58148 Traffic Regulation Order 25/17 – Comments

Subject: Subject: Clarification on "Travelling Safely – Greenbank to Meadows" Plans - TRO/25/17/IK

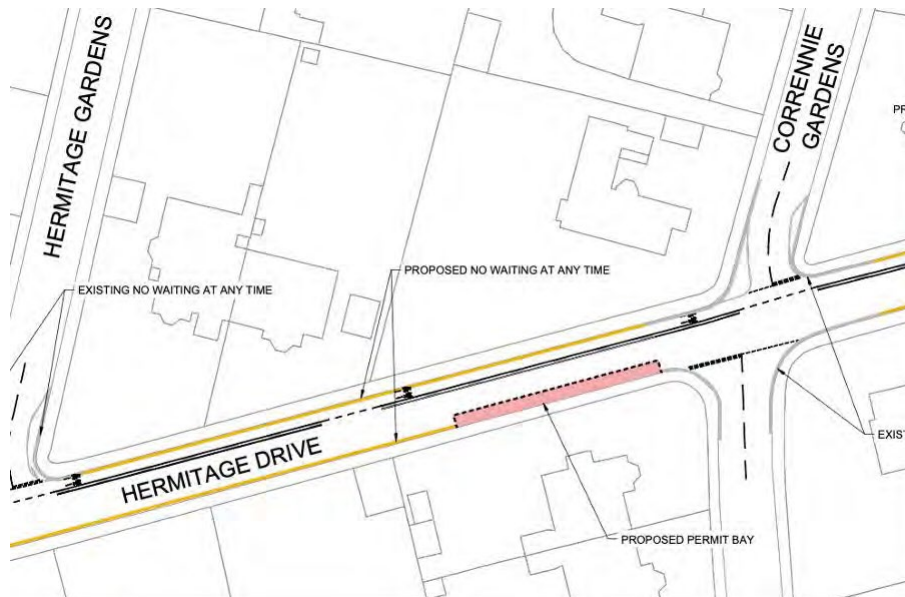
I refer to the proposed Permit Bay next to Corrennie Gardens (in pink) on Viewport 1 of TRO 25/17.

I have a serious safety concern for the few motorists (like a relative of mine) who have to exit the south cul-de-sac section of Corrennie Gardens on to Hermitage Drive westwards where the width is a very unacceptable 3.8 metres - on a road which is considered to be a Primary Route. The view of motorists will be severely compromised.

The second Road Safety Audit refers to a similar situation in Problem 3.10 (Braid Avenue Extents). It states:-

Description:

Formalised parking facilities are proposed along Braid Avenue in close proximity to existing accesses. When the parking bays are occupied, it is anticipated that:

- ▪ parked vehicles may obstruct visibility between drivers exiting the accesses to vehicles on the mainline, increasing the likelihood of side impact collisions (blue arrows above); and
- ▪ parked vehicles may obstruct visibility of cyclists travelling along the cycle way from drivers tuning into accesses (particularly where long lengths of parking bays are proposed) which may contribute to collisions between vehicles and cyclists (red arrows above).

Recommendation:

It is recommended that parking bay extents are amended to allow sufficient intervisibility between road users.

Therefore I request that you either shorten the Permit bay extents or move it along westward.
